SUBJECT: ST. LUCIE PLANT, UNIT 1 - ISSUANCE OF AMENDMENT REGARDING  
EXTENDED POWER UPRATE (TAC NO. ME5091)

AMENDMENT TO RENEWED FACILITY OPERATING LICENSE

Amendment No. 213  
Renewed License No. DPR-67

**SAFETY EVALUATION BY THE OFFICE OF NUCLEAR REACTOR  
REGULATION RELATED TO AMENDMENT NO. 213  
TO FACILITY OPERATING LICENSE NO. DPR-67  
FLORIDA POWER AND LIGHT COMPANY  
ST. LUCIE PLANT, UNIT NO. 1  
DOCKET NO. 50-335**

FIGURE 2.1-1: REACTOR CORE THERMAL MARGIN SAFETY LIMIT -  
FOUR REACTOR COOLANT PUMPS OPERATING

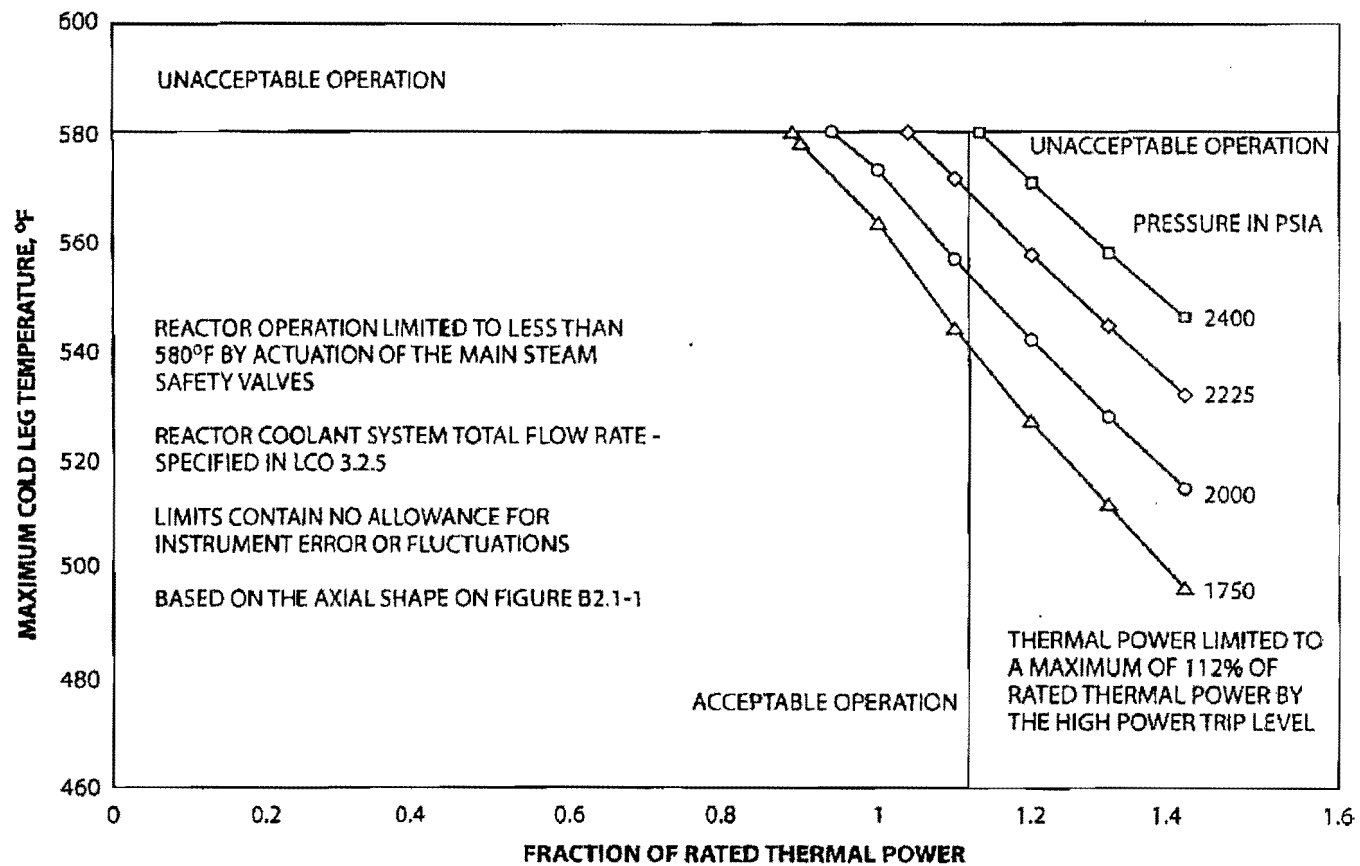
### 3.7 TS 2.1, SAFETY LIMITS – FIGURE 2.1-1: REACTOR CORE THERMAL MARGIN SAFETY LIMIT – FOUR REACTOR COOLANT PUMPS OPERATING

- Replacement for FIGURE 2.1-1 REACTOR CORE THERMAL MARGIN SAFETY LIMIT – FOUR REACTOR COOLANT PUMPS OPERATING, and

FIGURE 3.1-1 ST. LUCIE 1 MIN BAMT VOLUME  
VS STORED BAMT CONCENTRATION  
(MODES 1, 2, 3 and 4)

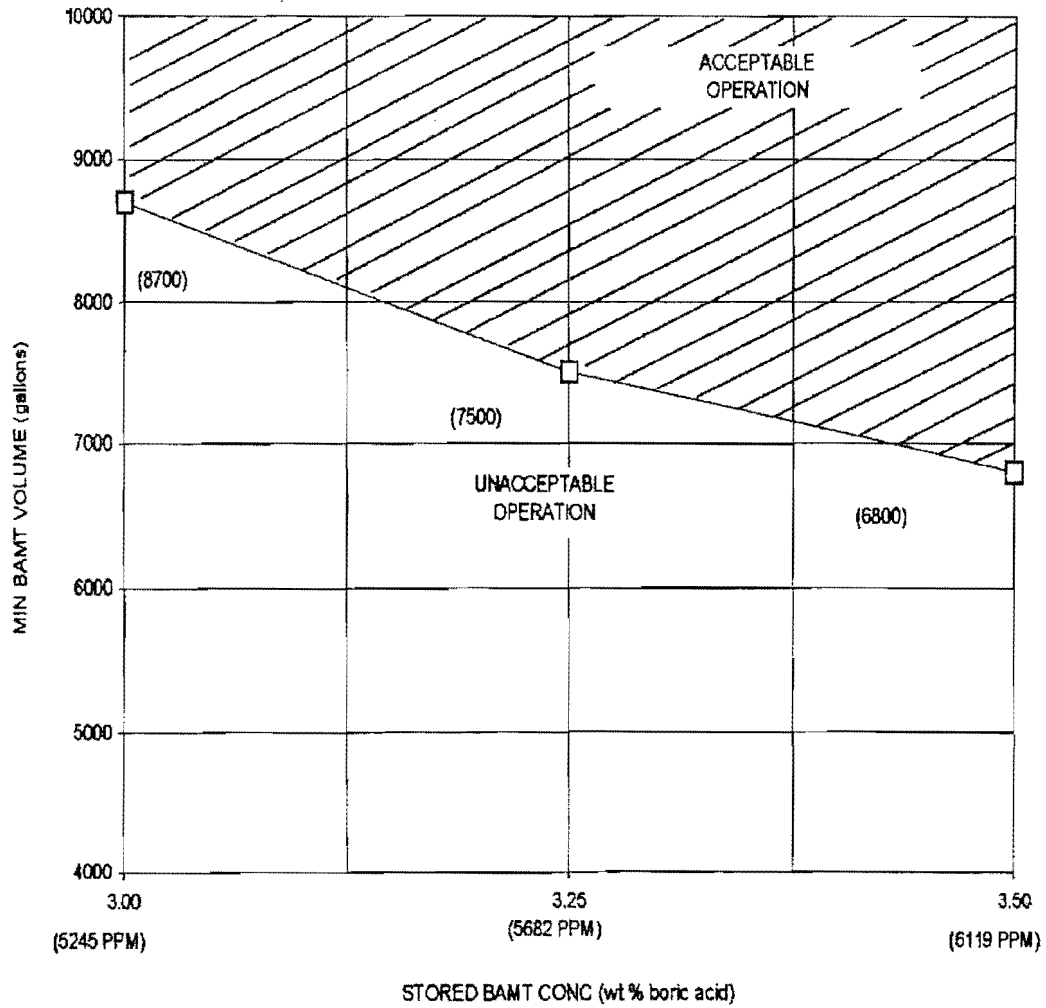
3.15 TS FIGURE 3.1-1, ST. LUCIE 1 MIN BAMT VOLUME VS STORED BAMT CONCENTRATION

– This figure is replaced with new TS Figure 3.1-1, entitled “FIGURE 3.1-1, ST. LUCIE 1 MIN BAMT VOLUME VS STORED BAMT CONCENTRATION (Modes 1, 2, 3 and 4)”, and

- TS Figure 3.1-1 is relocated from TS 3/4.1.2.7 to TS 3/4.1.2.8.

FIGURE 3.4-2a

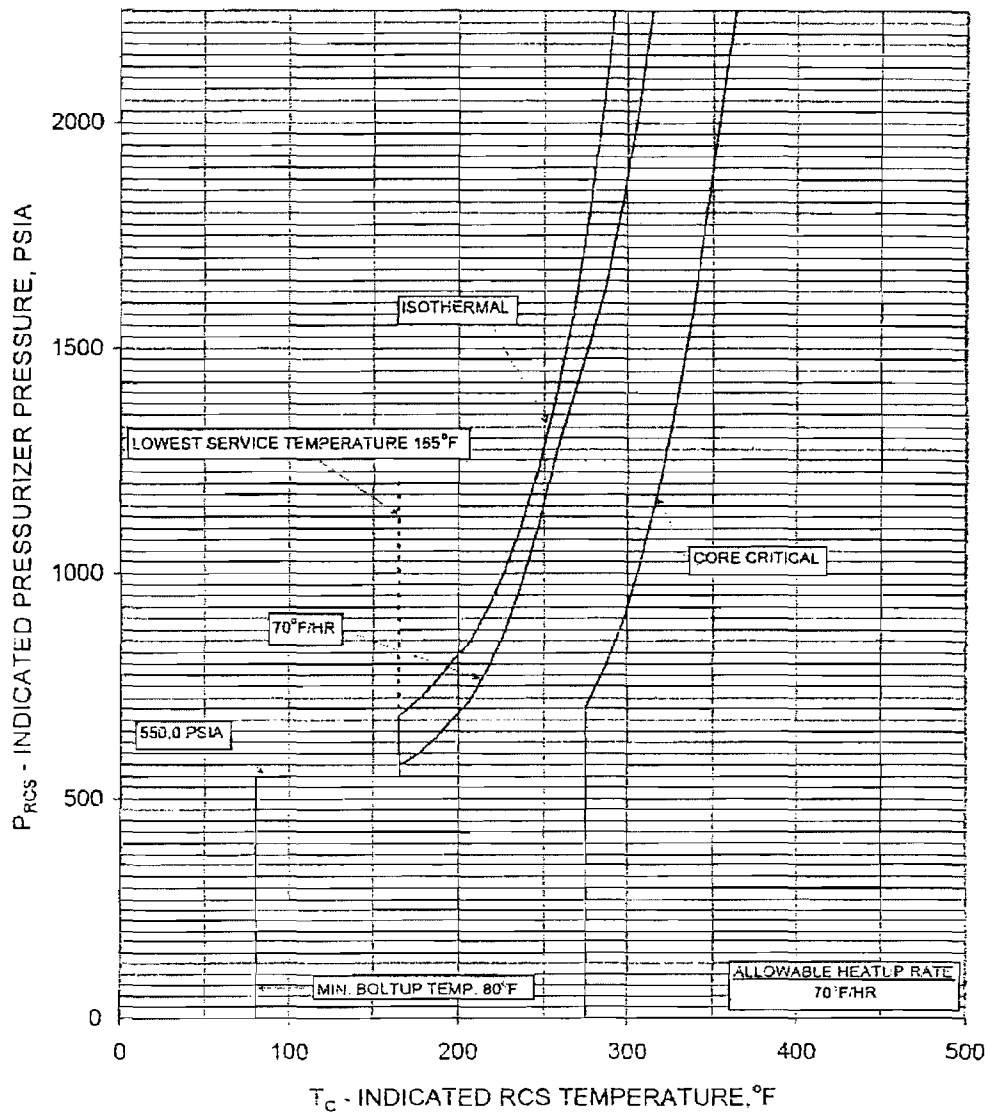
The licensee's current P-T operating limits are valid through 35 EFPY. To support the EPU, the licensee prepared new P-T limits good through 54 EFPY. The revised P-T curves are provided in Figures 3.4-2a and 3.4-2b of the proposed revised TS. The basis for the revised P-T limits is documented in Westinghouse Report WCAP-17197-NP, Revision 0, "St. Lucie Unit 1 RCS [reactor coolant system] Pressure and Temperature Limits and Low-Temperature Overpressure Protection [LTOP] Report for 54 Effective Full-Power Years" (Reference 3), provided as Appendix G to Reference 1. The P-T limits are based on the RV neutron fluence and ART values for 54 EFPY that account for the EPU. The revised P-T curves were developed using the methodology of the ASME Code, Section XI, Appendix G, as modified by topical report,

- 3.21 TS Figure 3.4-2a, ST. LUCIE UNIT 1 P/T LIMITS, 35 EFPY - HEATUP AND CORE CRITICAL is replaced with TS Figure 3.4-2a, ST. LUCIE UNIT 1 P/T LIMITS, 54 EFPY - HEATUP AND CORE CRITICAL.
- 3.22 TS Figure 3.4-2b, ST. LUCIE UNIT 1 P/T LIMITS, 35 EFPY - COOLDOWN AND INSERVICE TEST is replaced with TS Figure 3.4-2b, ST. LUCIE UNIT 1 P/T LIMITS, 54 EFPY - COOLDOWN AND INSERVICE TEST
- 3.23 TS Figure 3.4-3, ST. LUCIE UNIT 1 P/T LIMITS, 35 EFPY – MAXIMUM ALLOWABLE COOLDOWN RATES is deleted.
- 3.24 TS 3/4.4.13, REACTOR COOLANT SYSTEM – POWER OPERATED RELIEF VALVES
